**PLANNING ACT 2008
APPLICATION BY HIGHWAYS ENGLAND FOR AN ORDER GRANTING
DEVELOPMENT CONSENT FOR THE A303 SPARKFORD TO ILCHESTER
DUALLING
SUBMISSION MADE PURSUANT TO DEADLINE 4**

PLANNING INSPECTORATE REFERENCE TR010036

Deadline 4 – Somerset County Council - Written Submission of Oral Case made at Issue Specific and Compulsory Acquisition Hearings (26th February – 1st March)

Deadline 4 – Somerset County Council's response to 9.14 Topic Paper: Right of Way Y 30/28

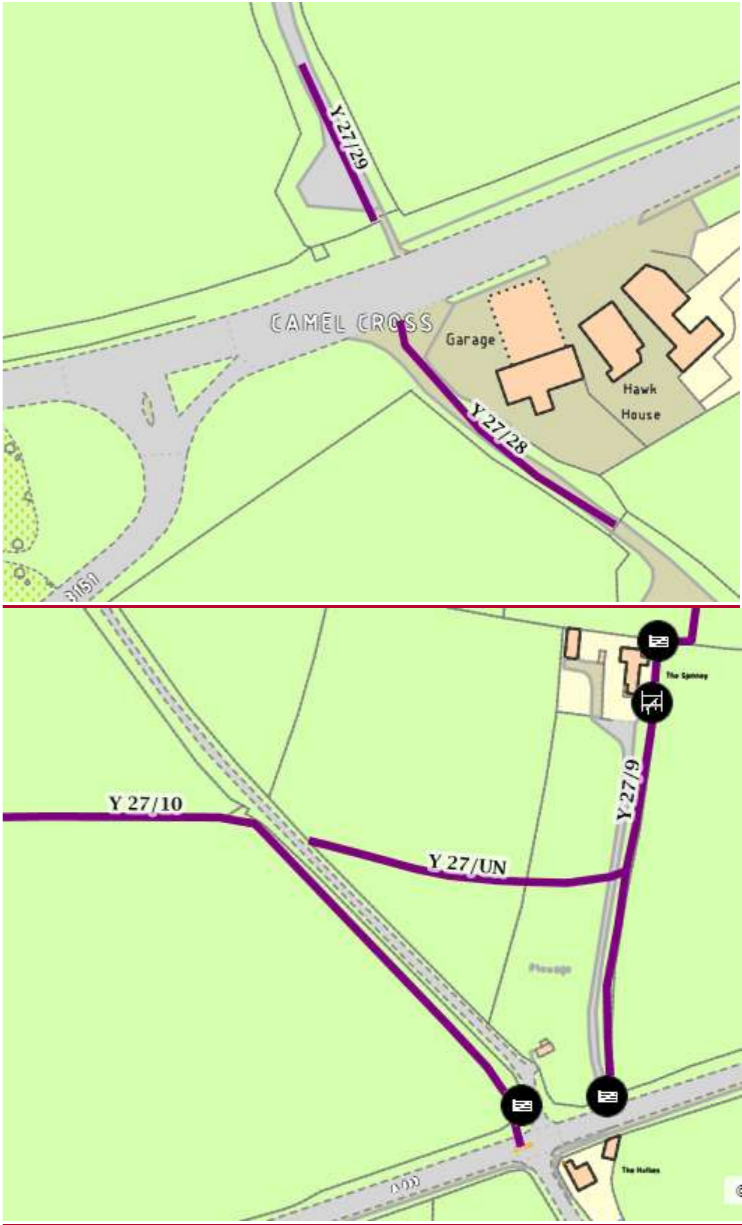
P10	Changes to path references resulting from updates to the Definitive Map & Statement (Sheets 1-4 Rights of Way & Access Plans, Draft DCO Schedules 3 & 4)	When the Ilchester bypass was provided there was a Side Road	Nomenclature of paths in DCO Schedules 3 &		The latest Rights of Way & Access Plans have been updated with the changes previously advised. However, the legal event modification order to update the Definitive

<p>Changes to path references resulting from updates to the Definitive Map & Statement</p>	<p>Order made in 1974. This made a number of changes to the rights of way. These changes have only recently been legally evented to bring the Definitive Map and Statement up to date.</p>	<p>4 and on the Rights of Way & Access Plans will need to be updated accordingly.</p>		<p>Map with the effect of the 1974 SRO actually adds Y 27/29 at Camel Cross, instead of Y 27/36. Due to this numbering, and to avoid confusion, it requires the previous Y 27/29 (a potential non-path resulting from the 1996 SRO) to be amended. This path is now being shown as Y 27/UN for the purposes of the online mapping. It has not been numbered as it has not been added to the Definitive Map and is likely to be subject of the revocation of the 1996 SRO.</p> <p>Up to date online mapping snips as follows:</p>  <p>The image contains two map snippets. The top snippet shows a road junction labeled 'CAMEL CROSS' with paths Y 27/29 and Y 27/28. Buildings labeled 'Garage' and 'Hawk House' are visible. The bottom snippet shows a different road junction with paths Y 27/10, Y 27/UN, and Y 27/9. Buildings labeled 'The Spinnery' and 'The Millers' are visible. A 'Perseus' label is also present in the bottom snippet.</p>

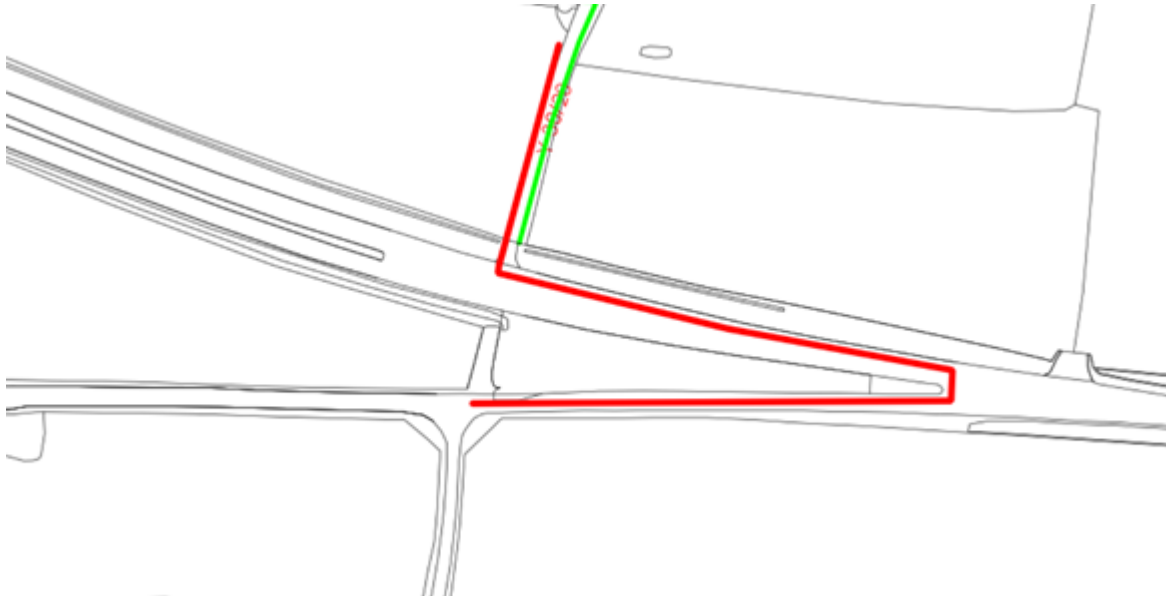
when the instrument came into force and that the Definitive Map should therefore be updated accordingly.

- 1.6 Whilst the Definitive Map & Statement (DMS) has recently been updated with the effect of the 1974 Ilchester bypass SRO, it has not been with the effect of the 1996 SRO.

- 1.7 It is the view of the Council that the 1996 order should be revoked prior to any confirmation of the Development Consent Order (DCO), particularly as the latter is reliant and almost wholly based on the highway network that resulted from the 1974 SRO and not the 1996 SRO. However, in doing this, the applicant needs to carefully consider whether any highways were created as a result of the SRO, and thus whether any should be retained by way of partial revocation. Y 30/29 being a potential example of a route that could be retained, if it was deemed to have been created by the SRO.
